ABWR

Subject: ABWR Drywell Head Buckling Capability

Enclosed are my response to NRC's questions 8 and 9 regarding the buckling capability of the ABWR drywell head. Please fax them to the NRC for their review. Responses to other 11 questions will be provided soon.

Fig. 8-1

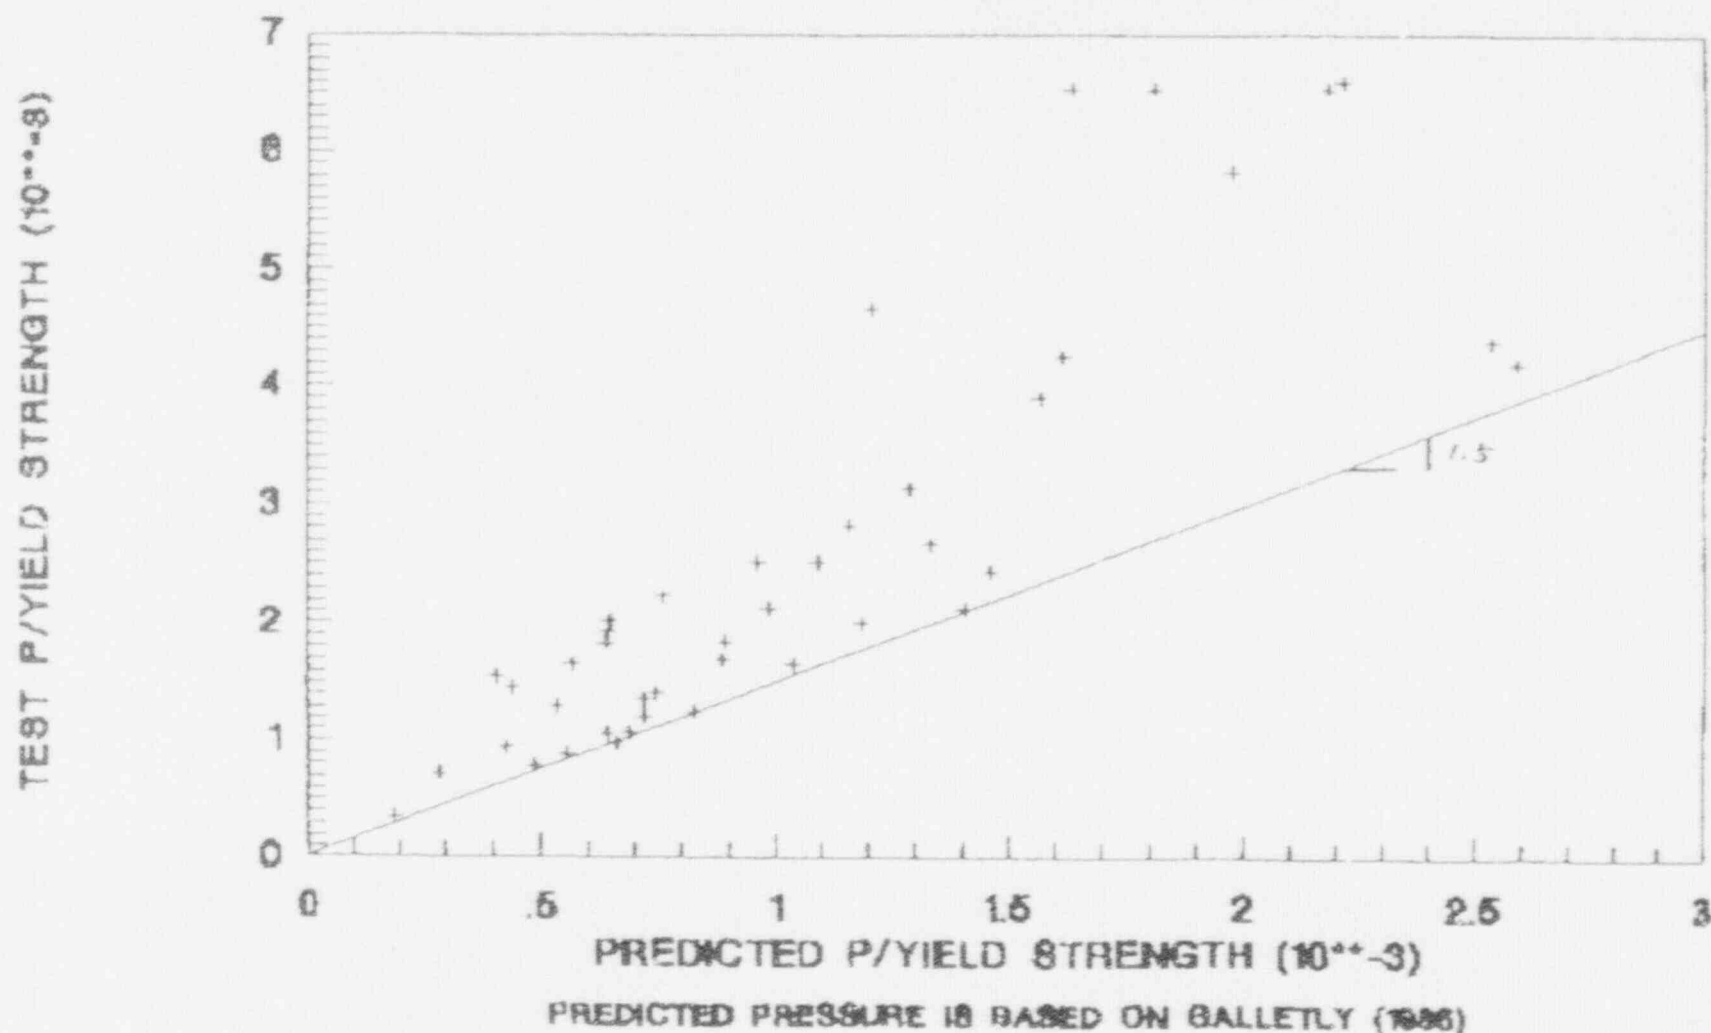
8. The equation (19F.3-2 in Ref. 1) used in calculating the internal pressure at critical buckling is based on a paper (Ref. 2) by Galletly and Radhamohan which limits its applicability to "D/t" between 500 to 1500. The "D/t" ratio for ABWR head is 324. Provide a justification for the use of the equation. A later paper by Galletly and Blachut (Ref. 3) provides equations which could be used for "D/t" ratio of 300 to 1500. The staff's calculation based on equation 3 in the reference gives a critical buckling pressure of 203 psig at 500/F. This corresponds to ASME Level C allowable buckling pressure of 81 psig. Provide justification for using 97 psig.

Galletly recently (Ref. 1) proposed a design equation for preventing buckling in fabricated torispherical shells under internal pressure. This equation is based on his previous studies (Refs. 2 and 3) and is formulated for design use with knock-down (capacity reduction) factors included. As compared to all known test results (43 in total), the ratios of the actual buckling pressure to the allowable buckling pressure predicted by this equation were found to range from 1.51 to 4.01. Hence, a minimum factor of safety of 1.5 is ensured by this equation.

The test data presented in Ref. 1 (excluding the test performed by Blenkin since no buckling was observed at the maximum test pressure) are summarized graphically in attached Fig. 8-1, showing the relationship between the test and predicted pressures. The predicted pressures, as can be seen, are at least 1.5 times lower than the test results. In order to gain more insight about the data variability, statistic analyses are performed and the results are given in Fig. 8-2. The PDF (probability density function) of the data shown by solid lines is the histogram of 42 data points expressed in terms of the ratio of test to predicted pressure. It is observed that the data can be reasonably approximated by the lognormal distribution. The median value of the test to predicted pressure ratios in the data set is 2.27 and the logarithmic standard deviation is 0.293. The resulting lognormal density and cumulative functions are shown in Fig. 8-2. The cumulative probability is 8% for the ratio up to 1.5. It means that the probability of the ratio of actual to predicted pressure being less than 1.5 is 8%. In other words, there is 92% confidence that the margin of safety against buckling is at least 1.5 when the Ref. 1 equation is used. The 1.5 factor of safety corresponding to 92th percentile is deemed sufficient for the assurance of no buckling failure against severe accident loadings of very low probabilities of occurrence. The Ref. 1 equation can be therefore used for the determination of level C buckling pressure of torispherical heads.

Using the Ref. 1 equation, the allowable buckling pressure for the ABWR drywell head is calculated to be 111 psig at 500°F. It is higher than 97 psig associated with general membrane yielding per level C stress intensity limits. Therefore, the governing level C pressure is 97 psig.

Fig. 8-2

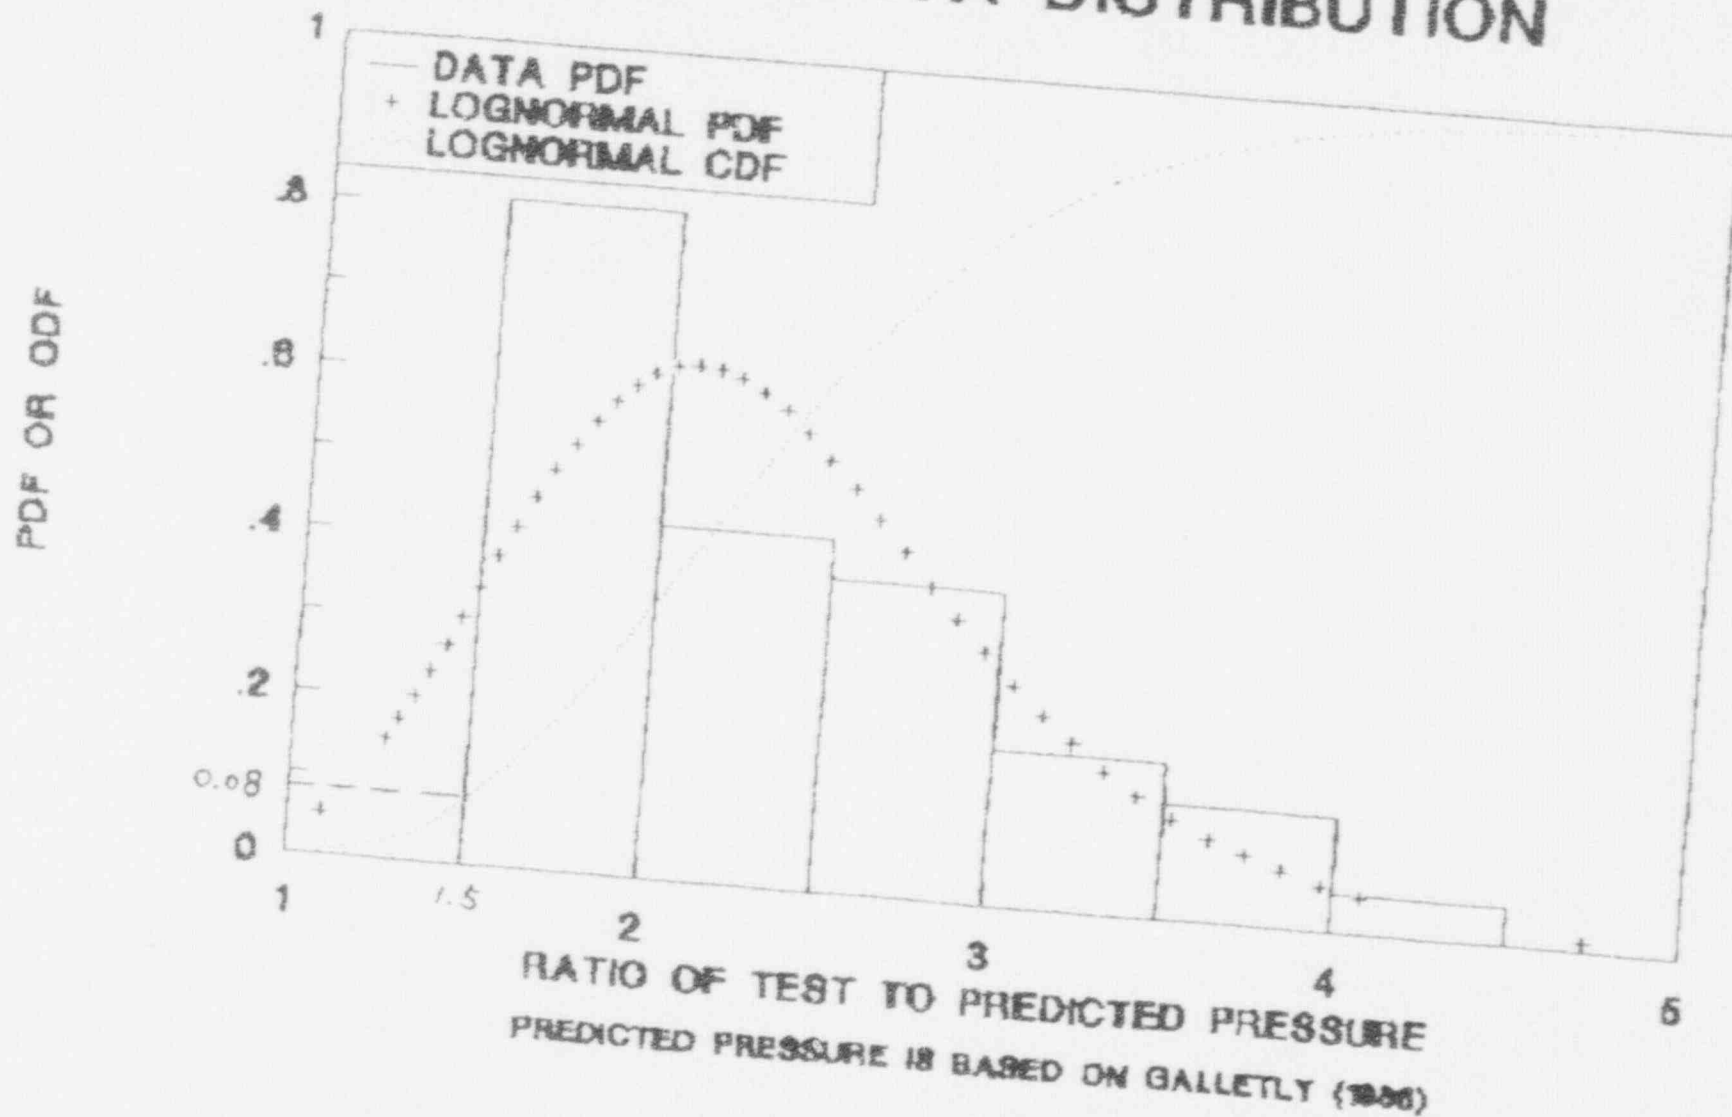
9. The authors of the same paper (Ref. 3) have made a comparison of their own equation and with that of Shield and Drucker (Ref. 4) used in Appendix 19F for axisymmetric yielding pressure, and find that the later is conservative. Hence the head failure pressure would be dictated by ASME Level D limit for compressive buckling stress. This will correspond to 101 psig at 500°F. Provide justification for using 134 psig as the median centered failure pressure (Fig. 19FA-1) for the drywell head.

The ASME level D is the design limit and should not be regarded as failure criterion for the purpose of ultimate strength prediction. As mentioned in the response to Question 8, the allowable buckling pressure of the ABWR drywell head is 111 psig at 500°F. The equation used has been shown to have a factor of safety of 1.5 as compared to the lower bound of all known test results. From a statistic study of test results (see response to Question 8), the median buckling pressure is estimated to be 2.27 times the value predicted by the reference equation. Subsequently, the critical buckling pressures of the ABWR drywell head are:

Lower bound	=	1.5 * 111	=	166 psig
Best estimate	=	2.27 * 111	=	252 psig

They are higher than the yielding pressure of 134 psig calculated according to the Shield and Drucker equation (Ref. 1). Buckling is thus not the controlling failure mode.
